# Access Compliance Report

## Public Rights-of-Way (Curb Ramps)

Intersection ID: 52293	Main Street: N_I-85_SERVICE_RD	Cross Street: N_TRYON_ST	Location: W
ADA ID: 798994C913C0	Ramp Type: Directional1	Initial Pass/Fail: Pass	Overall Compliance: No
		Severity Score: 7.5

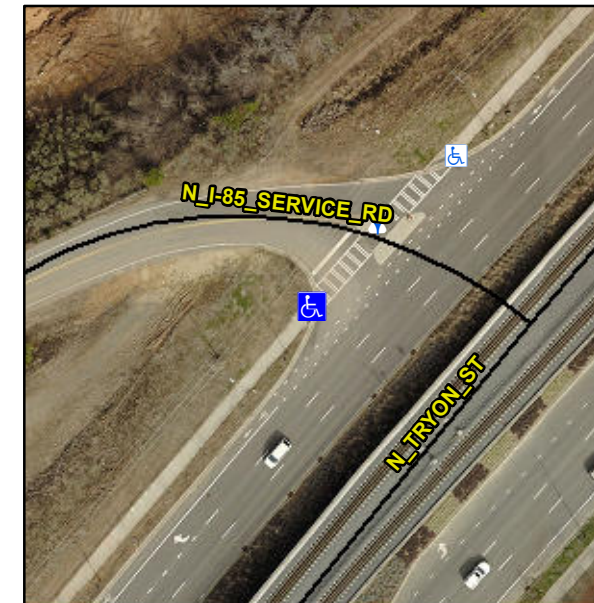
**R304.5.2, R302.7.2**

**Remove & Replace Entire Ramp.  
Grind Gutter Lip.**
